# Technical Bulletin

TB #:0711-1A  
Date: Dec 3, 2007  
Page 1 of 3

**MODEL NUMBER :** VXR-7000VC

**Reason For Technical Bulletin:** Correct receiver desense when using an external duplexer.

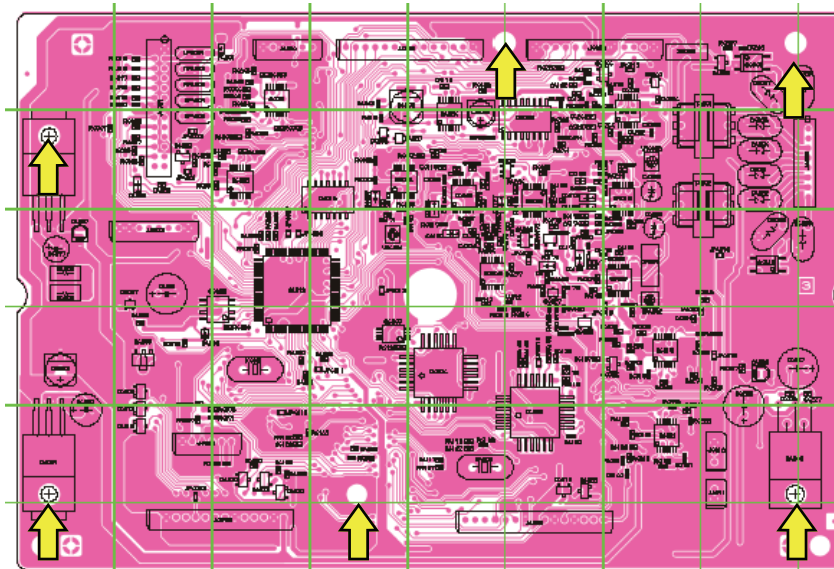
1. Remove the 10 screws affixing the top cover of the repeater, and remove the cover. Screws are indicated by the arrows below.

- Remove the 6 screws (indicated by yellow arrows) holding the Control board to the chassis. Remove the Control board from the VXR-7000.

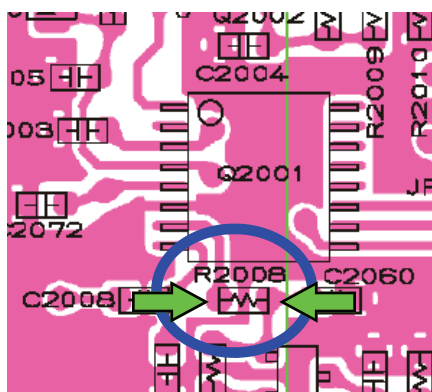
- Remove the 9 screws holding the shield case cover to the chassis. This shield cover will be visible when the Control board has been removed from the VXR-7000. (Refer to the VXR-7000VC Service manual, Exploded View & Miscellaneous Parts page). Remove the shield cover from the VXR-7000VC chassis. The TX unit and RX unit will now be visible. The TX unit is located on the right side of the chassis, as viewed from the front of the VXR-7000.
- Remove the 4 screws holding the TX unit to the chassis. Unplug the RF jumper cable from J2001(TX OUT) jack. (Refer to the VXR-7000VC Service manual, Exploded View & Miscellaneous Parts page). Remove the TX unit from the VXR-7000.
- Solder capacitor C2075 on top of resistor R2008, as shown below.

Solder C2075 on top of R2008 at the two points indicated by the green arrows.

<b>REF #</b>	<b>Old Part #</b>	<b>New Part #</b>	<b>Qty.</b>	<b>New Part Desc.</b>
C2075	N/A	K22174249	1	470 pF capacitor
